UNITED STATES PATENT AND TRADEMARK OFFICE

10/822,992

Office Action Summary

DETAILED ACTION

EXAMINERS FIGURE 1

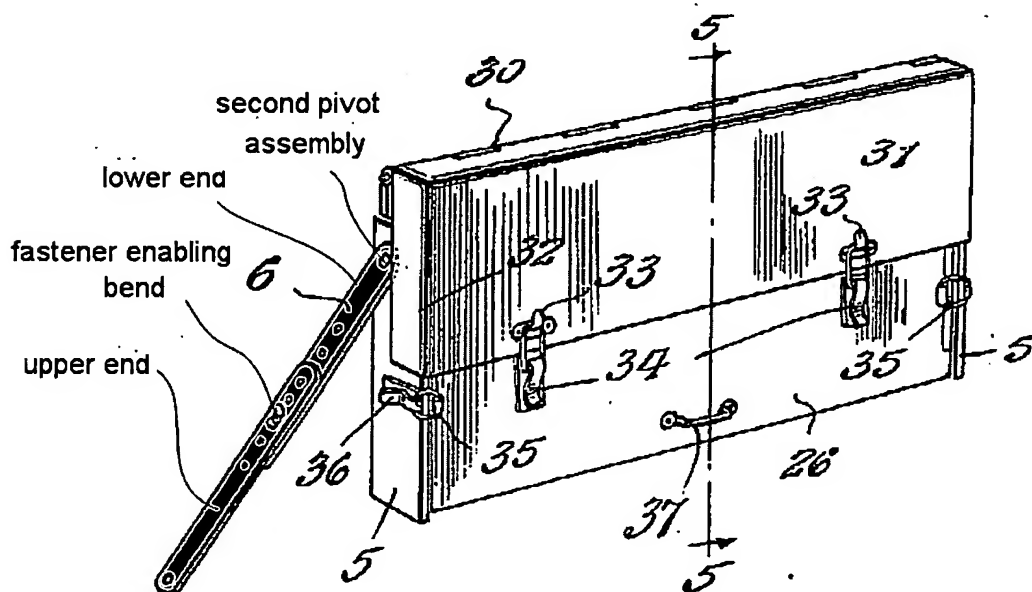
Regarding claim 4, the bracket 6 comprises an upper and lower end, wherein the upper and lower end are adjustably or telescopically connected such that one could form a bend at the meeting ends, and wherein the upper end is attached to a mounting surface of the vehicle 1 (see Examiners Figure 1).

Regarding claim 13, Hanson discloses a body (a front 3, a back (26), a bottom (plates 8 and 9), a first and second side, each having plates 14 and 15), a top 31, and a bracket 6 comprising an upper and lower end, wherein the upper and lower end are adjustably or telescopically connected such that one could form a bend at the meeting ends, and wherein the upper end is attached to a mounting surface of the vehicle 1, and the lower end being pivotally connected to the container (see lines 50-61 and Examiners Figure 1).

Examiners Figure 2

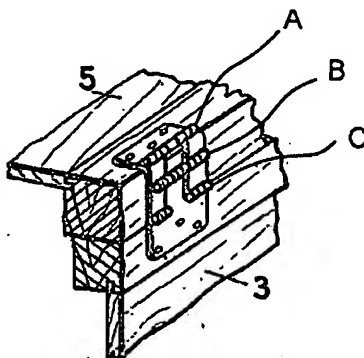
is formed (Figure 3) and a second position (Figure 1) in which the box is collapsed, the hinge assembly (Examiners Figure 2) having a first pivot assembly A connected to the top 5 and a second pivot assembly C connected to the body, the hinge assembly enabling the top to be positioned flat against the body when in the collapsed position.
